STAFF RECOMMENDATION

4122 Aberdeen Road

June 20, 2018

Application: New construction-outbuilding/ Violation
District: Cherokee Park Neighborhood Conservation Zoning Overlay
Council District: 24
Map and Parcel Number: 10308020100
Applicant: Louis Roberts
Project Lead: Melissa Baldock, melissa.baldock@nashville.gov

Figure 2. The dormer constructed on top of the garage.

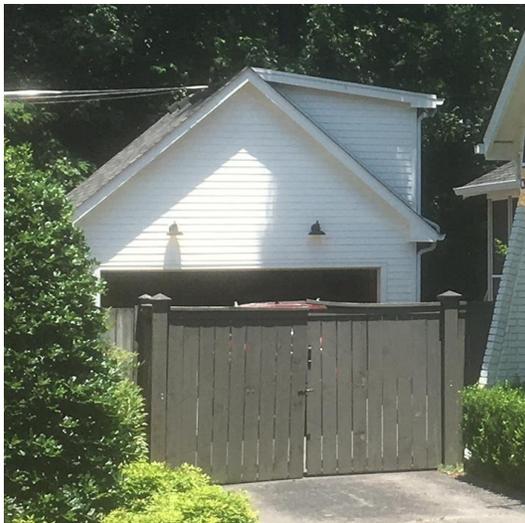
In March 2016, MHZC staff issued an administrative preservation permit for the construction of a twenty foot by twenty-two foot (20' X 22') one-story outbuilding that would not be used as a DADU. The applicant subsequently constructed a dormer on the outbuilding which was not part of the approved plans and which does not meet the design guidelines in size and scale (Figure 2).

In this case, the dormer stacks on the wall below, rather than being inset two feet (2'). Also, the dormer's width is approximately twenty-one feet (21') wide, and the roof is twenty-four feet (24') wide. The dormer's width therefore approximately eighty-eight percent (88%) of the roof's width. In the past, the Commission has found that dormers stacked on the wall below increase the perception of height and massing, which does not meet the design guidelines. Staff finds that the dormer's lack of two foot (2') inset and its width do not meet the design guidelines. Staff therefore recommends that the dormer be altered so that it is inset two feet (2') from the wall below and is no wider than twelve feet (12'), which is one-half the width of the roof.

Recommendation Summary: Staff recommends that the dormer be reduced in size so that it is inset two feet (2') from the wall below and has a maximum width of twelve feet (12'). The dormer's size and scale should be reduced so that it meets Section II.B.1.h. of the Cherokee Park Neighborhood Conservation Zoning Overlay Design Guidelines.

Figure 3. Front elevation approved as part of the preservation permit.

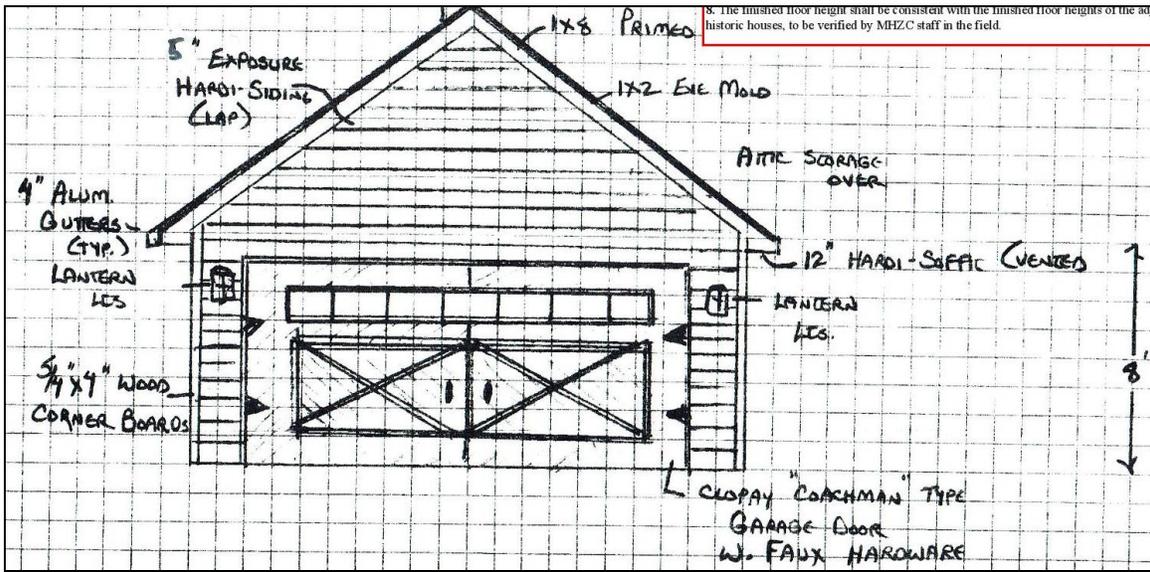
The drawings attached to the preservation permit from 2016 show a twenty foot by twenty-two foot (20' X 22') garage that has an eave height of approximately eight feet (8') and a ridge height of sixteen feet (16') (Figures 3 & 4). No dormers were shown on the plans and no second story floor plan was provided.
